Access Compliance Report

(Curb Ramps)

Intersection ID: 31504	Main Street: SUNMAN_RD	Cross Street: TIRANO_CT	Location: S
ADA ID: 272A2C199047	Ramp Type: PerpDiag	Initial Pass/Fail: Fail	Overall Compliance: No
Severity Score: 33.75			
Codes/Mitigation Info/Possible Solution		Field Measurements/Component Compliance

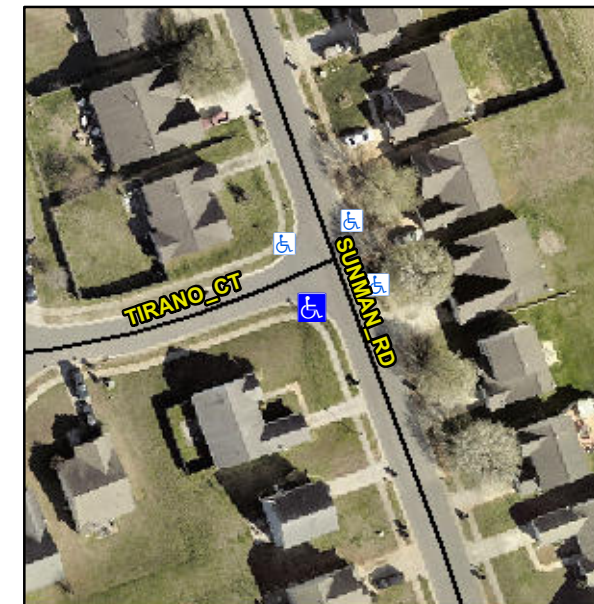
R304.5.1, R304.5.3

Compliance	Description	Data	Compliance	Description	Data
N/A	Ramp Length (in)	52.0	Yes	Ramp Slope (%)	5.1
No	Ramp Width (in)	43.5	No	Ramp XSlope (%)	10.4
N/A	Flare Type LT	N/A	N/A	Flare Type RT	N/A
N/A	Flare Slope LT (%)	N/A	N/A	Flare Slope RT (%)	N/A
N/A	Flare Traversable LT?	N/A	N/A	Flare Traversable RT?	N/A
N/A	Landing Length (in)	N/A	N/A	DWS Provided?	N/A
N/A	Landing Width (in)	N/A	N/A	DWS Contrast?	N/A
N/A	Landing Slope (%)	N/A	N/A	DWS Length (in)	N/A
N/A	Landing X Slope (%)	N/A	N/A	DWS Full Width?	N/A
N/A	Landing Curb? (Y/N)	N/A	N/A	DWS Offset (in)	N/A
N/A	Shared Landing?	N/A			
N/A	Gutter Ponding?	N/A	N/A	Gutter Slope (%)	N/A
N/A	Gutter Lip Ht (in)	N/A	N/A	Gutter X Slope (%)	N/A
N/A	Painted X Walk1?	No	N/A	Painted X Walk2?	No
	X Walk 1 Direction	To E		X Walk 2 Direction	To N
N/A	X Walk 1 Width (in)	N/A	N/A	X Walk 2 Width (in)	N/A
	X Walk 1 Slope (%)	3.4		X Walk 2 Slope (%)	7.6
	X Walk 1 X Slope (%)	8.0		X Walk 2 X Slope (%)	5.4

Remove & Replace Curb Ramp With Two New Directional Ramps or Equivalent.
